## **RESPONSES TO PROJECT WORK GROUP REQUESTS Hooksett US 3/NH 28 – Project 29611**

**Re:** Working Group Meeting #7  
Responses to Requests

A PWG meeting was held December 11, 2023 to solicit input for a preferred alternative which includes an additional lane in each direction along US 3/NH 28, a roundabout at the Mammoth Road intersection, curbed median islands at selected locations, 6’ sidewalks, as well as 5’ shoulders. As an alternative solution at the US 3/NH 28 and Mammoth Road intersection, a signalized intersection is also being considered.

Figure 1

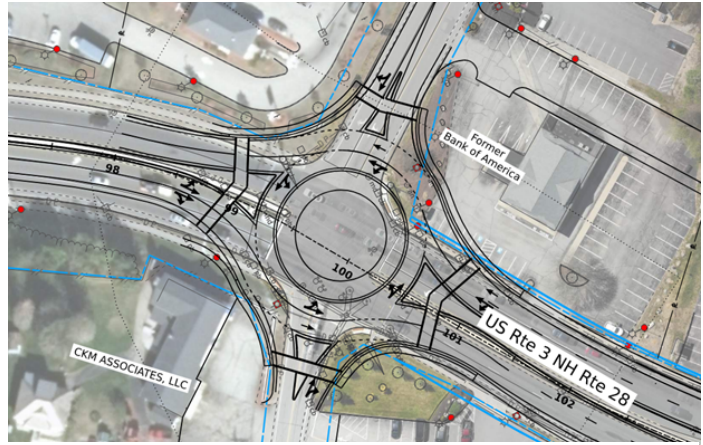
- *NHDOT will assess installing a roundabout at Alice Avenue.*

- *NHDOT has developed a roundabout concept at the Alice Avenue intersection (see figure 1). It is anticipated that the roundabout has an improved “level-of-service” compared the signalized intersection however the roundabout does also have increased impacts beyond the right-of-way in all four corners when compared to the signal.*

*This concept will be discussed further with the PWG, City and public at upcoming meetings.*

Figure 2

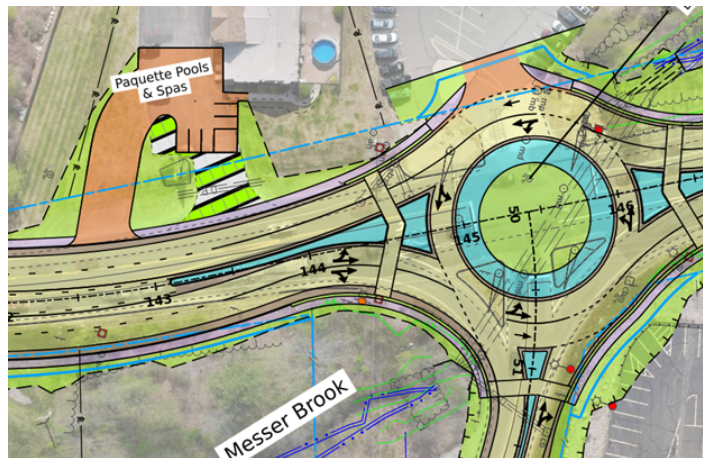
- *NHDOT will assess shortening the splitter island associated with the Mammoth Road intersection roundabout option for Paquette Pools and Spas.*

- *The splitter island has been shortened to allow full access into/out of Paquette’s driveway (see figure 2). This refinement does require that the driveway be relocated 75’ to the south from its current location. The driveway layout for Paquette’s is the same for both the roundabout and signalized intersection option at Mammoth Road and US 3 and allows full access as currently exists.*

Figure 3

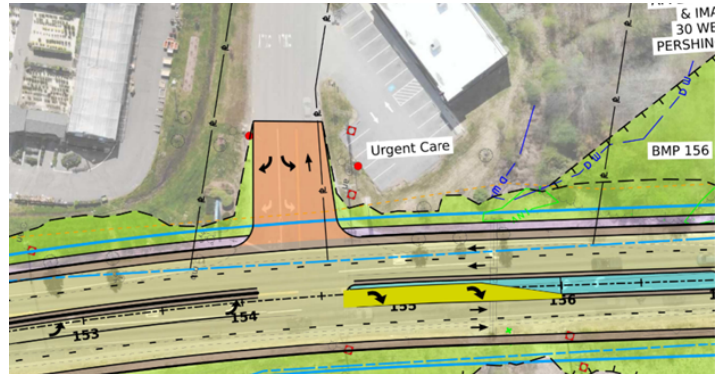
- *NHDOT will assess if left turn merge lanes would be a possibility along the corridor.*

○ *The concept for left turn merge lanes was evaluated (see figure 3). The concept proposed by the PWG envisioned utilizing a portion of the median island width to allow*

vehicles to exit a site and to move into the “left turn merge lane” and then to merge into the travel lanes.

*This concept would require drivers to make an increased number of decisions to merge into traffic at higher speeds compared to having a vehicle move from the side access location and into the median area between the two islands. Use of a “left turn merge lane” would also require drivers in this area to complete a merge maneuver prior to the lane ending. This would cause forced merging and increased potential for vehicular conflicts.*

*Additionally, providing the “left turn merge lane” will cause confusion to thru travelers who expect a left turn lane may be opening with movements into the “left turn merge lanes”.*

*“Left turn merge lanes” have not been incorporated into the proposed layouts.*

Figure 4

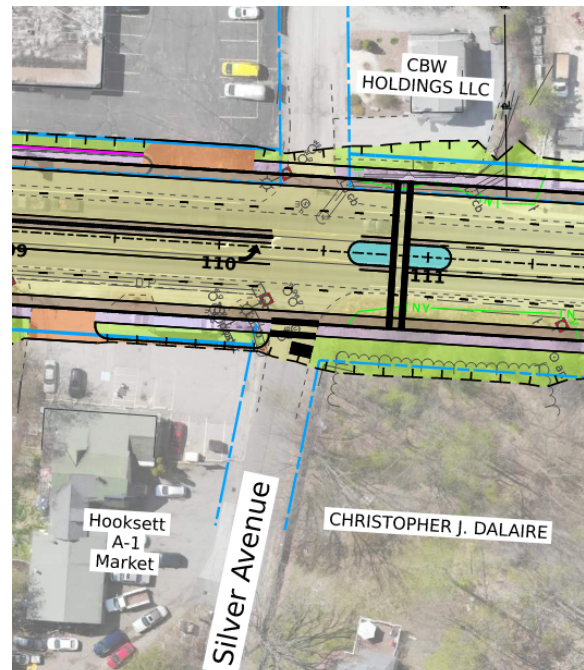
- **NHDOT will assess including a cross walk at Silver Avenue.**

- *A crosswalk will be considered at this location and discussed further in context with other crossing locations. In conjunction with the crosswalk, a raised median island will be required to allow for pedestrian safety area in the instance that they are not able to completely cross US 3 (see figure 4).*

Figure 5

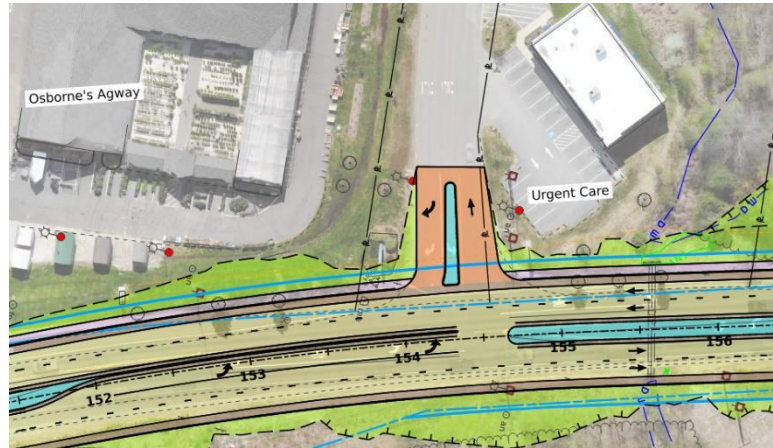
- ***NHDOT will post the latest roll plots and presentation to the NHDOT website.***
  - *All the information from the PWG meeting (reference plans, meeting minutes, etc.), as well as all information from subsequent discussions (including this “Response to Requests”) will be posted at the project website noted above with all our public outreach information.*
- ***NHDOT will look at options to refine/preclude ways to discourage left turns OUT of Cinemagic way (on the roundabout design plots).***

- *A layout has been developed and incorporated into the plans to preclude left turns from Cinemagic Way for the **roundabout intersection concept** at Mammoth Road and US 3 (see figure 5).*

*This restriction was recommended by the PWG to eliminate turning movement conflicts, thereby enhancing safety, as the roundabout would allow travelers to reverse direction to head north along US 3 from Cinemagic Way.*
